## National Committee on Uniform Traffic Control Devices

1 **Proposed Language as approved by the NCUTCD on June 23, 2011, for new section on**  
2 **Pedestrian Channelizing Devices**

4 **Section 6F.xx Pedestrian Channelizing Devices** [suggest placing after Section 6F.63  
5 Channelizing Devices]

# Figure 6F-XX Pedestrian Channelizing Device

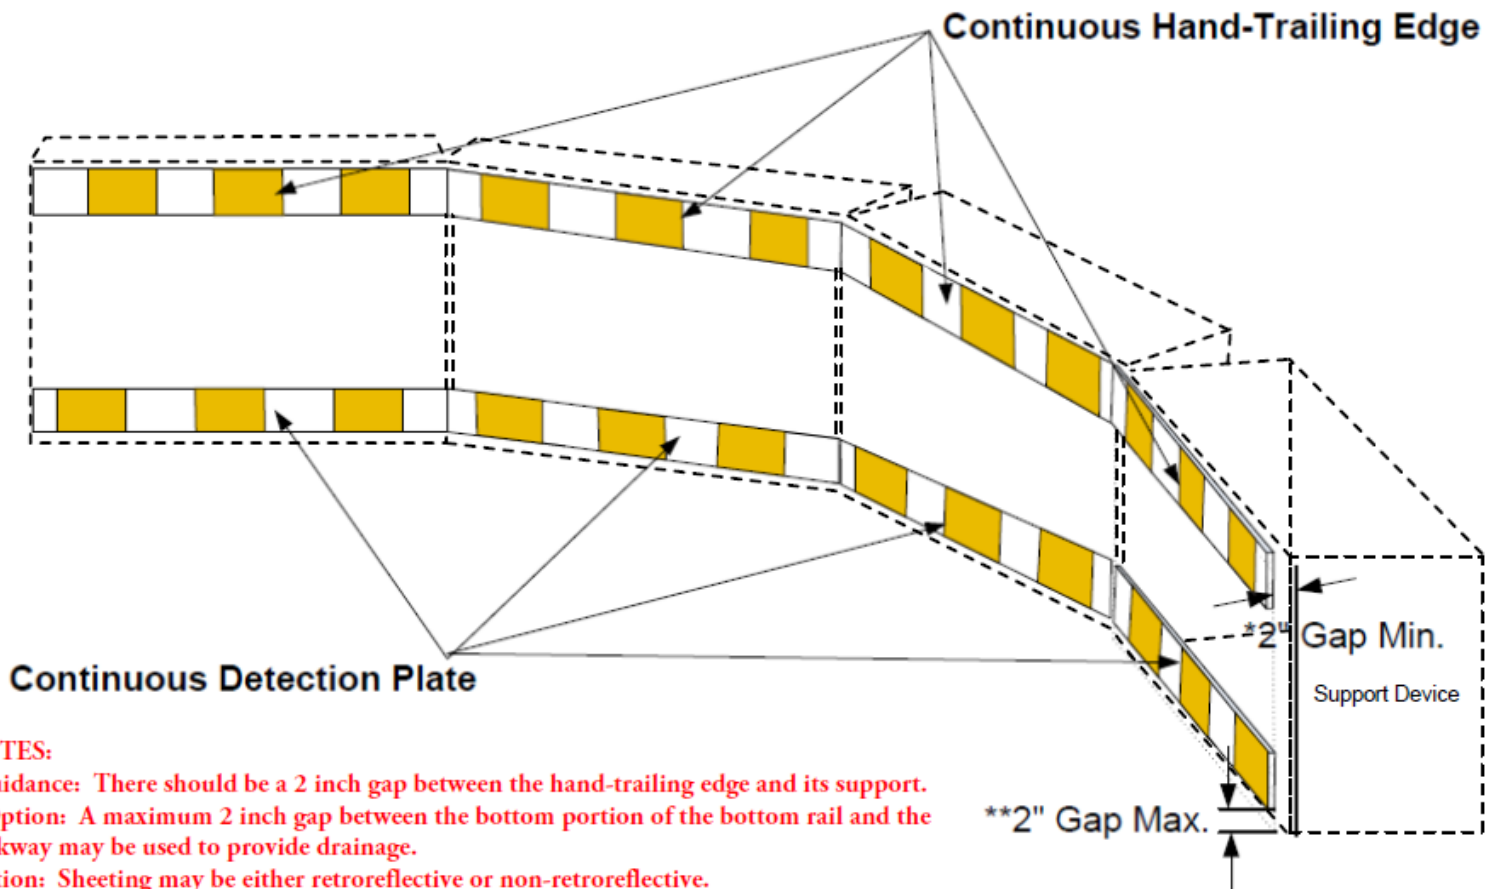
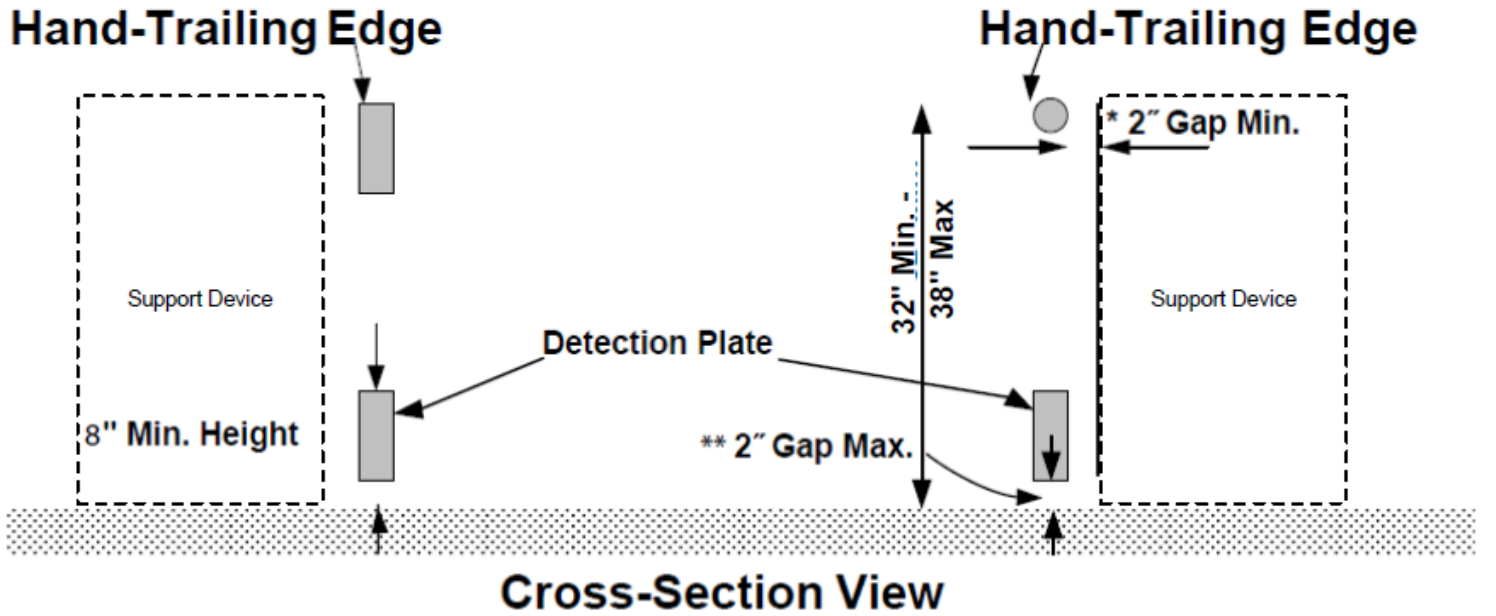
A Hand-Trailing Edge is the upper surface of the upper rail on a pedestrian channelizing device, as shown in Figure xx. It is provided to allow pedestrians with limited vision to follow the pedestrian channelizing device with their hand. The Hand-Trailing Edge is not a weight bearing railing.

\*\*\*The Handtrailing Edge should be 32" to 38" above the pavement or ground.

- \*Guidance: There should be a 2 inch gap between the hand-trailing edge and its support.
- \*\*Option: A maximum 2 inch gap between the bottom portion of the bottom rail and the walkway may be used to provide drainage.
- Option: Sheeting may be either retroreflective or non-retroreflective.
- Option: Sheeting panels may be either vertical or at a 45 degree angle.
- Option: Hand-Trailing Edges and/or Detection Plates are optional for continuous walls.
